FM Notification Report Serial Number 10-06

Fairbanks Morse Engine

10CFR 21.21 (d)(3)(ii) Notification

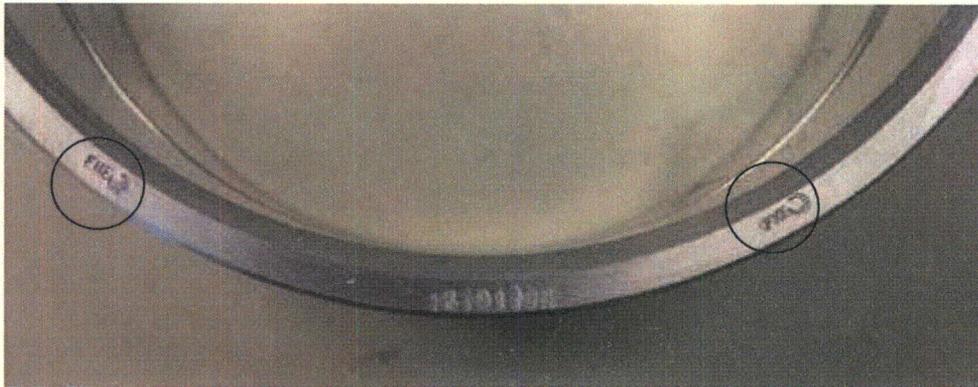
All bearings that are suspect for linear indications are stamped with two FM swirl logos as shown in the photo. Linear indications have only occurred on bearings machined from the latest permanent mold castings which are identified with two FM swirl logos as shown:

All aluminum OP bearings stamped with a double FME logo, as listed in the previous table, are suspect for having linear indications and should be returned to FME for inspection.

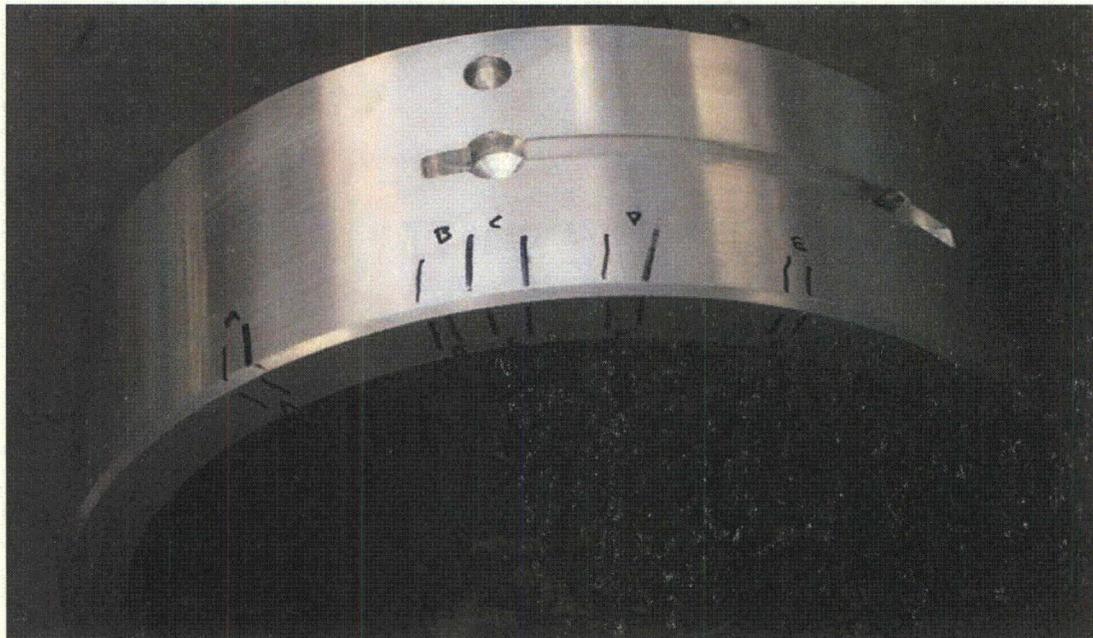
Linear indications (hot tears) were observed on one main bearing by the FM production inspector. The indications were only on one edge of the bearing. The indications went across the entire edge and extended about 1 inch deep into the bearing, being visible on the outside diameter and the inside diameter for about 1 inch. Subsequent 100% liquid penetrant inspection (PT) of all finished bearings in stock has found linear indications on 13 of 454 bearings (3% reject rate) made from permanent mold castings.

The following photo shows the location of the linear indications marked along one edge of the bearing:

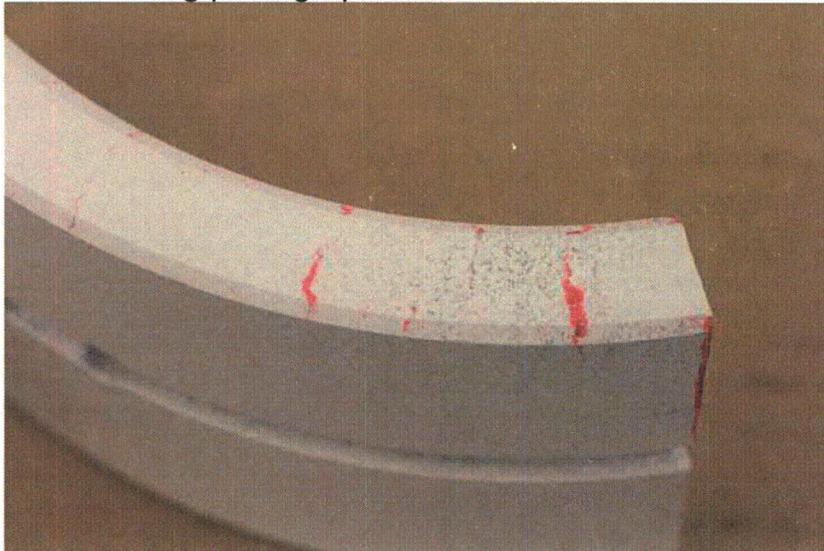
The following photograph shows linear indications observed by PT:
